To All Lamborghini Dealers and Licensed Service Point
From Customer Service Department
Subject Starter Ventilation Enhancement
Group 9.11.00
Date 15th/11/2013
Pages 6

Starter ventilation enhancement.

All Lamborghini Aventador LP 700 Coupe and Roadster MY 12,13 and 14 from VIN CLA0091 to VIN ELA02238.

Identification

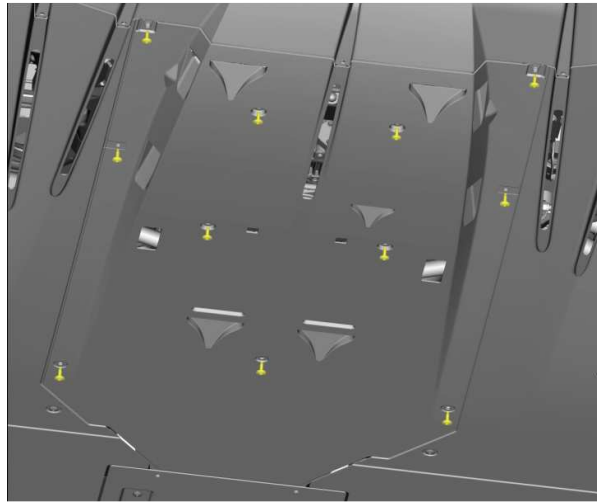
1	Check the illustration below to distinguish old from new screw.			
	<table border="1"><tr><td data-bbox="416 468 1050 535">Original (with threadlocker)</td><td data-bbox="416 535 1131 792"></td></tr><tr><td data-bbox="416 792 919 1003"></td><td data-bbox="919 1003 1131 1061">New (NO threadlocker)</td></tr></table>	Original (with threadlocker)		
Original (with threadlocker)				
	New (NO threadlocker)

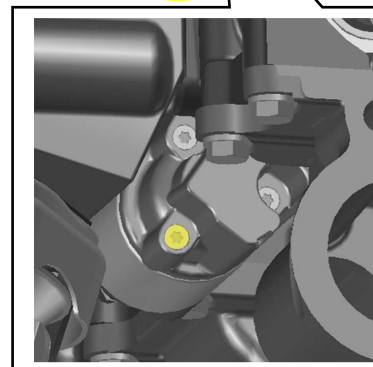
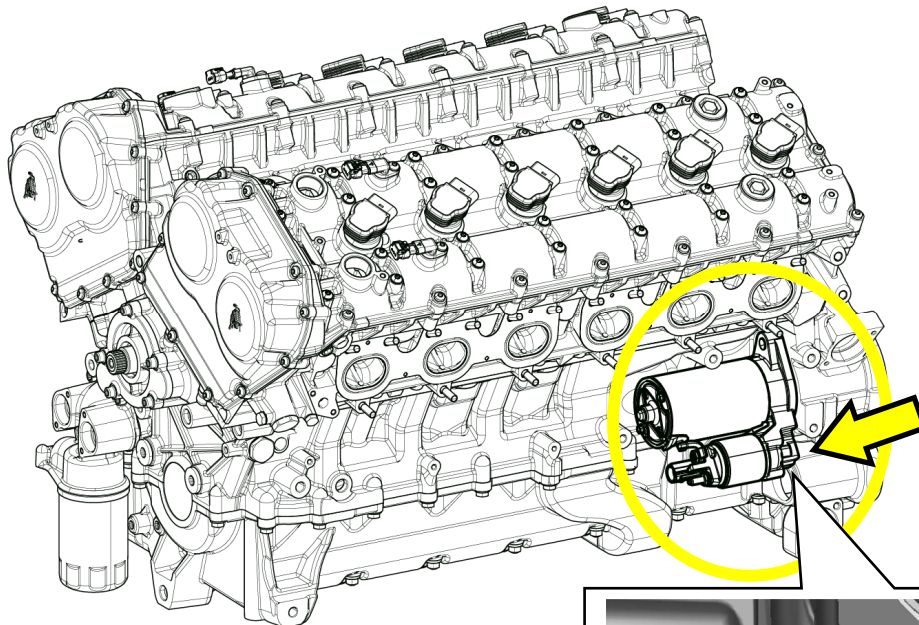
2	Place vehicle on suitable hoist and lift it properly to work safe from risks.
3	Identify the working Area and the lower screw to be replaced

Detect the screw to be replaced: lower screw of starter motor.

<p>6</p>	<p>Unfasten and remove the screw.</p>	
<p>7</p>	<p>Insert the new screw (p/n 470198317) and fasten without tightening it.</p> <p>Unscrew completely the screw so that all the eventual threadlocker residues might come off from the tapped hole.</p> <p>Clean eventually the screw from threadlocker remainings.</p> <p>Reinstall and tighten completely the new screw.</p> <p>Torque: 6 Nm</p>
